Wabco OnGuard Display Discrepancy

TSB-54-364-FTL

► New Cascadia

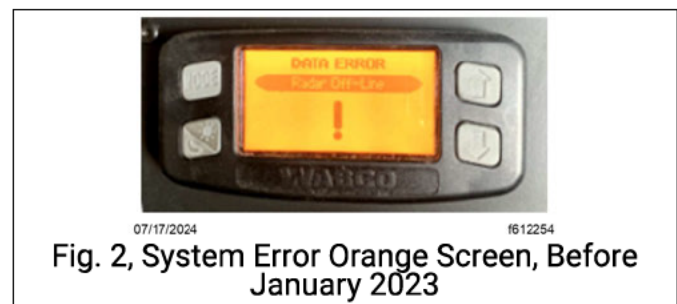
On New Cascadia vehicles built from January 1, 2023 through January 26, 2024, updates to the central gateway (CGW) 81Z-008 software (1,596 vehicles) and 81Z-010 software (161 vehicles) in the beginning of January 2023 incorporated a broadcast source address (SA) 42, specifically assigned to the forward radar located in the front bumper. However, Wabco OnGuard systems mistakenly identify the SNA message from the CGW for SA 42 as active. Consequently, if the radar front end (RDF) harness gets disconnected, the Wabco OnGuard driver display does not switch to the default orange system error screen. See Fig. 2. Instead, it shows the blue driving screen, which is the correct 'NO CMS' warning message for the driver, but it does not display the intended orange color under this circumstance.

In the event of the RDF becoming disconnected, there will be no additional graphics or MPH values noted on the screen other than what is displayed in Fig. 1.

This issue has been resolved with an updated CGW software version. If a vehicle has this issue, updating the CGW to the newest available software will resolve it.
